FIRE SAFETY INSPECTION REPORT

MULTIFABS LTD

ACCORD
on Fire and Building Safety in Bangladesh

March 28, 2015

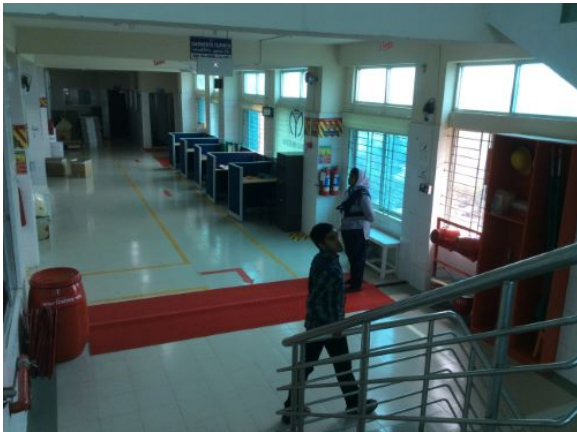
F-4	Fire Rated Construction	The EMR room is not separated by fire-rated construction due to non-rated door and opening in the north exit stair enclosure.	Separate the EMR room by a minimum 2-hr fire rated construction for high rise. Seal and protect all openings to maintain the required fire separations. Provide proper ventilation and consult a qualified engineer.	Within 3 months
-----	-------------------------	---	--	-----------------

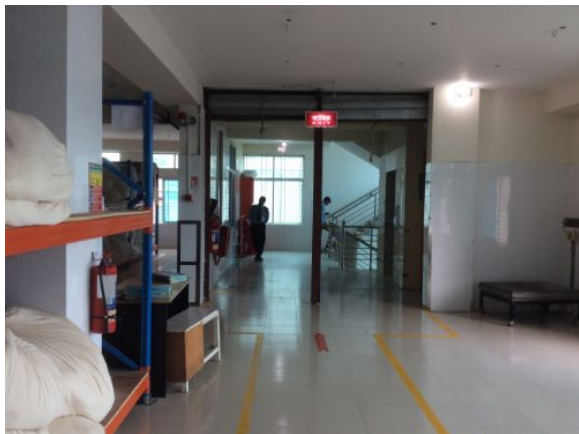
F-9	Fire Rated Construction	Storage rooms discharge directly into all exit stair enclosures.	Openings from exit enclosure to storage spaces shall be provided with a vestibule with fire rated construction and openings. Provide a 1.5 hr. fire rated door on the exit stair side and a 1-hr. fire rated door on the storage room side. Ensure that the fire rating of the vestibule construction matches that of the exit stair enclosure.	Within 3 months
-----	-------------------------	--	--	-----------------

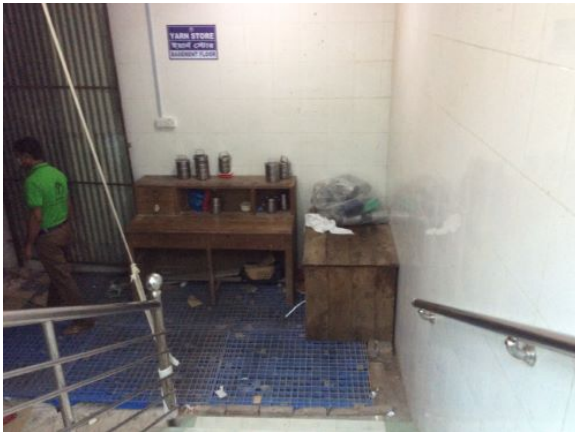
F-14	Egress	Storage was located in all exit stairs on the basement.	Remove all storage from exit stairs and egress paths.	Immediately
------	--------	---	---	-------------

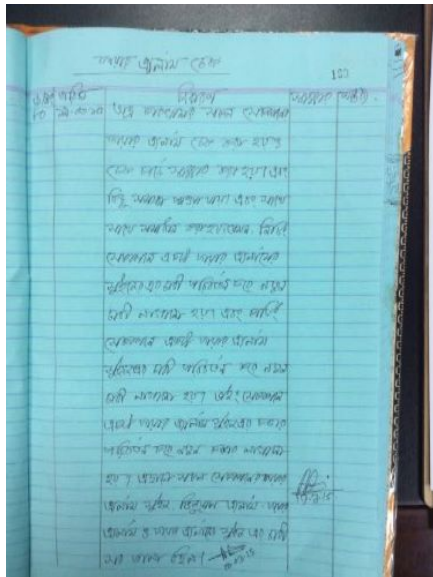
F-26	Fire Protection	Inspection, testing and maintenance for the fire alarm system is not in accordance with NFPA 72.	Inspect, test and maintain the fire alarm system and keep written records on-site, in accordance with NFPA 72.	Within 3 months
------	-----------------	--	--	-----------------

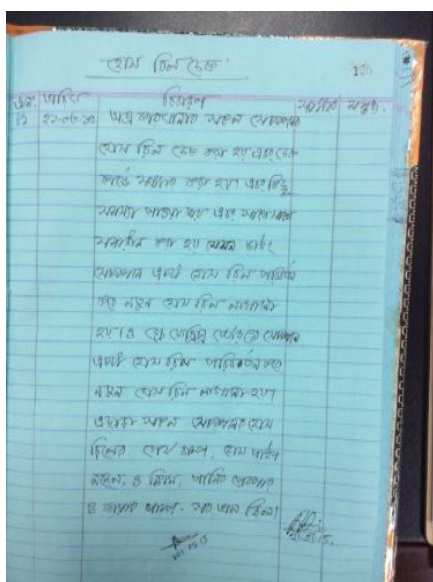
F-27	Fire Protection	Inspection, testing and maintenance of the standpipe system is not in accordance with NFPA 14.	Inspect, test and maintain the standpipe system and keep written records on-site, in accordance with NFPA 14.	Within 3 months
------	-----------------	--	---	-----------------

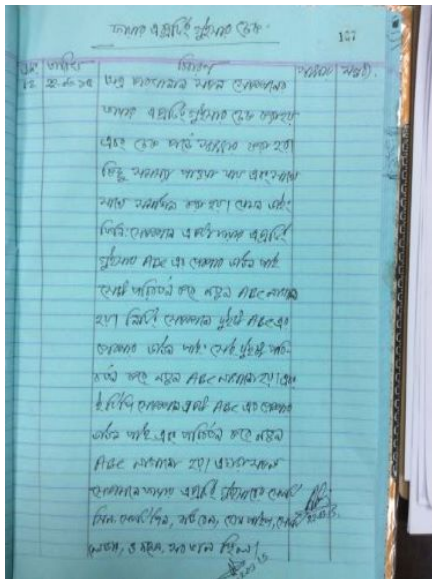
F-28	Fire Protection	Fire department connection is not provided.	Provide fire department connection in accordance with ACCORD standard 5.5.4.	Within 3 months
F-29	Fire Protection	Inspection, testing and maintenance of portable fire extinguishers is not in accordance with NFPA 10.	Inspect, test and maintain the portable fire extinguishers and keep written records on-site, in accordance with NFPA 10.	Within 3 months

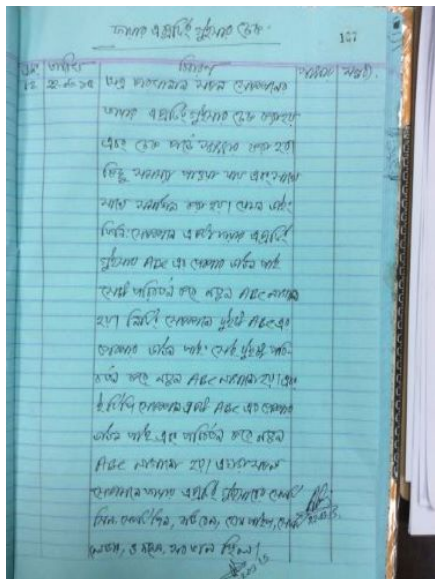
F-8	Fire Protection	Inspection, testing and maintenance of portable fire extinguishers is not in accordance with NFPA 10.	Inspect, test and maintain the portable fire extinguishers and keep written records on-site, in accordance with NFPA 10.	Within 3 months
-----	-----------------	---	--	-----------------

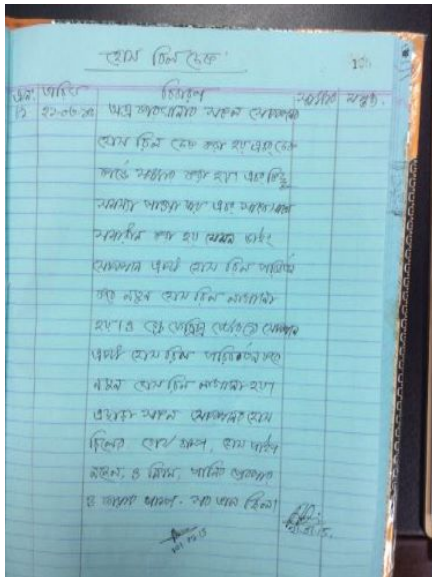
F-10	Fire Protection	Inspection, testing and maintenance of the standpipe system is not in accordance with NFPA 14.	Inspect, test and maintain the standpipe system and keep written records on-site, in accordance with NFPA 14.	Within 3 months
------	-----------------	--	---	-----------------

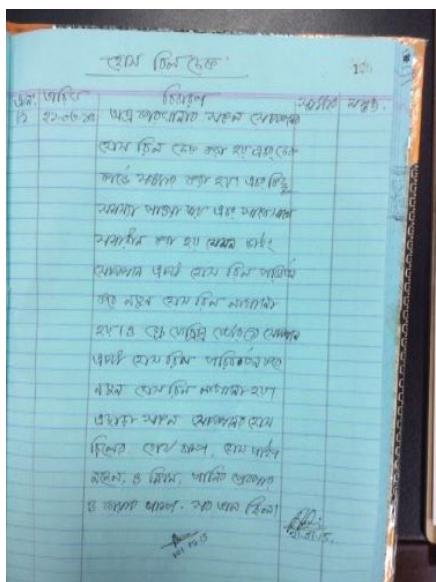
F-16	Fire Protection	Inspection, testing and maintenance of the standpipe system is not in accordance with NFPA 14.	Inspect, test and maintain the standpipe system and keep written records on-site, in accordance with NFPA 14.	Within 3 months
------	-----------------	--	---	-----------------

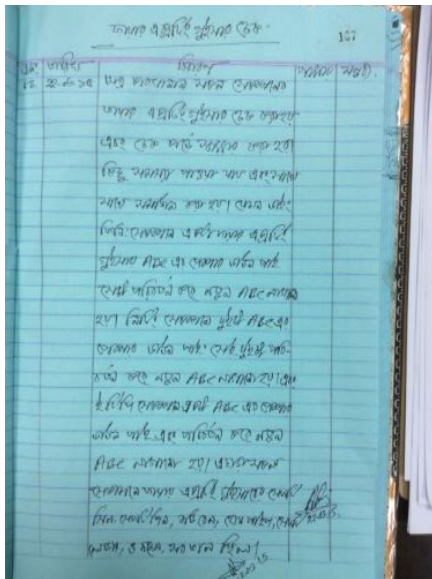
F-17	Fire Protection	Fire department connection is not provided.	Provide fire department connection in accordance with ACCORD standard 5.5.4.	Within 3 months
F-18	Fire Protection	Inspection, testing and maintenance of portable fire extinguishers is not in accordance with NFPA 10.	Inspect, test and maintain the portable fire extinguishers and keep written records on-site, in accordance with NFPA 10.	Within 3 months

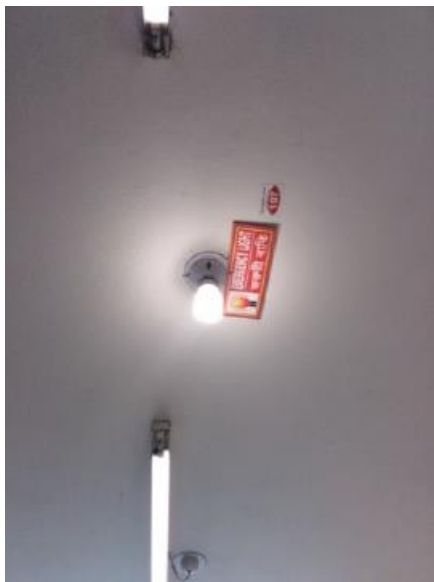
F-22	Egress Lighting	Based on the number and location of emergency lights observed, adequate illumination levels are not anticipated along egress routes on the ground floor.	Test the emergency lighting system on each floor and provide additional emergency fixtures to supply adequate illumination along the means of egress. Provide a minimum illumination of 10 lux at the floor level within exit stairs and along exit discharge paths and a minimum 2.5 lux along exit access aisles.	Within 3 months
------	-----------------	--	---	-----------------
